GENERAL INFORMATION

Applicant:	Aeon VP Bloomington, LLC (Owner and Developer)
Location:	1900 East 86 th Street
Request:	1) Rezoning from R-4 Multiple-Family Residential to RM-24(PD) High Density Residential (Planned Development). 2) Preliminary Development Plans and Final Development Plans to add 172 new residential units in two four-story multi-family residential apartment buildings to an existing multi-family residential site.
Existing Land Use and Zoning:	Multiple family residential – apartments; zoned R-4 Multiple Family Residential
Surrounding Land Use and Zoning:	North – Hotel and office; zoned C-4(PD) South – Single-family residential; zoned R-1 East – Townhomes and fire station; zoned R-4, R-4(PD) and R-1 West – State Highway 77
Comprehensive Plan Designation:	High Density Residential

Case PL2020-69

Project Description: Rezoning from R-4 to RM-24(PD), Preliminary Development Plans, and Final Development Plans to add 172 new residential units in two four-story multi-family residential apartment buildings to an existing multi-family residential site.

Figure 1: Rezoning from R-4 to RM-24(PD)

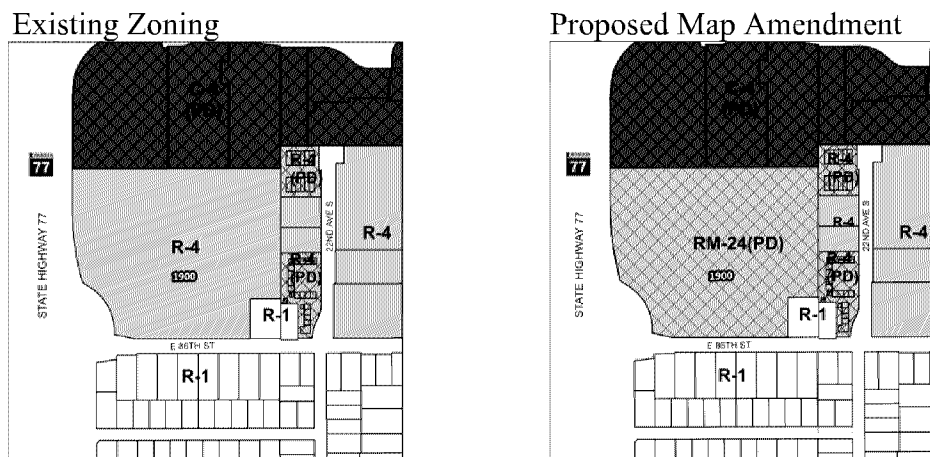
To allow for the expansion of the existing multi-family residential development, the applicant requests rezoning the property from R-4 to RM-24(PD), as shown in Figure 1. The total number of dwelling units proposed would comply with the maximum density restrictions of the RM-24 zoning district when factoring in density bonuses permitted within the Opportunity Housing Ordinance (Sec. 9.16). The maximum density allowed in the RM-24 zoning district is 24 units per acre. Given the site area of 17.67 acres, a typical residential development could have a maximum number of 424 units or dwellings under the RM-24 zoning designation. However, the OHO would allow 138 bonus dwelling units above the maximum density as a result of the affordable units provided. More information about this calculation can be found in the Opportunity Housing Ordinance section that follows. As a result, this site could have 568 dwelling units based upon the quantity of affordable units proposed. The proposed quantity of 478 apartments would be compliant with the RM-24 base zoning designation in light of the OHO density bonus tool.

In terms of consistency with the Comprehensive Plan, the subject property is designated High Density Residential. The High Density Residential designation is intended for residential properties with a residential density greater than 10 units per acre. In addition, the intent of the RM-24

District is to “provide appropriate development standards for multiple-family residential uses with access to arterial or collector streets in proximity to neighborhood commercial uses and public open space.” The subject property abuts East 86th Street, a major collector roadway, and State Highway 77, a principal arterial. The site is in proximity to neighborhood commercial uses along the East Old Shakopee Road corridor and the Mall of America. Wright’s Lake Park and Bass Ponds trail head provide nearby opportunities for public open space and recreation. Transit service (local routes 538A and 539B) is available on East 86th Street, as well as the Metro Blue Line LRT at Mall of America Station.

The R-4 zoning district, the current zoning of the subject property, is the zoning district that was historically applied to multiple-family residential properties in Bloomington when the site was developed. As multi-family residential properties develop or expand, it is common for sites to be rezoned to accommodate the residential density proposed, provided the proposed uses are consistent with the Comprehensive Plan. The proposed zoning district, RM-24, allows for a higher residential density desired by the applicant. The maximum residential density of the existing R-4 zoning district is 12 units per acre, whereas the RM-24 district allows 24 units per acre. Rezoning to the RM-24 zoning district is necessary to allow for the expansion of the existing multi-family residential campus, as the existing density of the site is already above what is permitted in the R-4 district.

To evaluate the public benefit associated with the requested zoning change, staff references the Comprehensive Plan to verify the proposed project is consistent with the City’s land use and housing goals. The Comprehensive Plan Housing Element encourages development of multi-family housing on sites near transit, services, amenities and employment. In addition, the Housing Element supports the development of life cycle housing. New multi-family residential development is a critical component of the diverse housing stock needed to achieve life cycle housing in the community. Both the Comprehensive Plan and the One Bloomington Strategic Plan also support the creation of additional affordable housing. The proposed rezoning supports multiple goals of the Comprehensive Plan and Strategic Plan and will benefit the public. Staff recommends approval of the request to rezone the property from R-1(PD) to RM-24(PD).

In Case #PL2020-69, I move to adopt an ordinance rezoning 1900 East 86th Street from R-4 to RM-24(PD).
